Access Compliance Report

Public Rights-of-Way

(Curb Ramps)

Intersection ID: 54422	Main Street: LISMORE_LN	Cross Street: KILKENNY_DR	Location: W
ADA ID: 12AFA0FD72CD	Ramp Type: Directional1	Initial Pass/Fail: Pass	Overall Compliance: No
Severity Score: 20			
Codes/Mitigation Info/Possible Solution		Field Measurements/Component Compliance

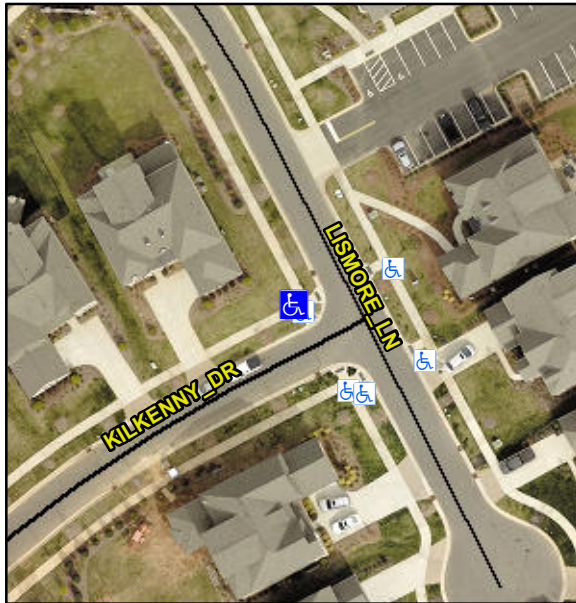
**Not Found, R302.7.2, R304.5.4,
R304.5.3**

Compliance	Description	Data	Compliance	Description	Data
N/A	Ramp Length (in)	77.0	Yes	Grade Break?	Yes
Yes	Ramp Width (in)	59.0	Yes	Grade Break Slope (%)	0.8
Yes	Ramp Slope (%)	1.0	Yes	Grade Break XSlope (%)	2.0
Yes	Ramp XSlope (%)	1.2			
N/A	Flare Type LT	N/A	N/A	Flare Type RT	N/A
N/A	Flare Slope LT (%)	4.0	N/A	Flare Slope RT (%)	9.5
N/A	Flare Traversable LT?	No	N/A	Flare Traversable RT?	No
Yes	Landing Length (in)	59.0	Yes	DWS Provided?	Yes
Yes	Landing Width (in)	59.0	Yes	DWS Contrast?	Yes
Yes	Landing Slope (%)	1.5	Yes	DWS Length (in)	24.0
Yes	Landing X Slope (%)	1.5	Yes	DWS Full Width?	Yes
N/A	Landing Curb? (Y/N)	No	Yes	DWS Offset LT (in)	1.0
N/A	Shared Landing?	Yes	Yes	DWS Offset RT (in)	13.5
Yes	Gutter Ponding?	No	No	Gutter Slope (%)	5.2
No	Gutter Lip Ht (in)	2.0	No	Gutter X Slope (%)	2.7
N/A	Painted X Walk1?	No		Road Slope (%)	3.2
	X Walk 1 Direction	To SE		Road X Slope (%)	1.3
	X Walk 1 Width (in)	N/A		Clear Space?	Yes

X Walk 1 Slope (%)	3.2	N/A	Clear Space to XWalk (in)	N/A
	X Walk 1 X Slope (%)	1.3	Yes	Storm Grate/Utility Hazard?	No
N/A	Ramp inside XWalk1?	N/A		Storm Grate/Utility Type	
Yes	Any Obstructions?	No			N/A
	Obstruction Type		Yes	Surface Condition? (G/P)	Good
			N/A	Curb Slope (%)	10.4

**Remove & Replace Entire Ramp.
Remove & Replace Gutter.**
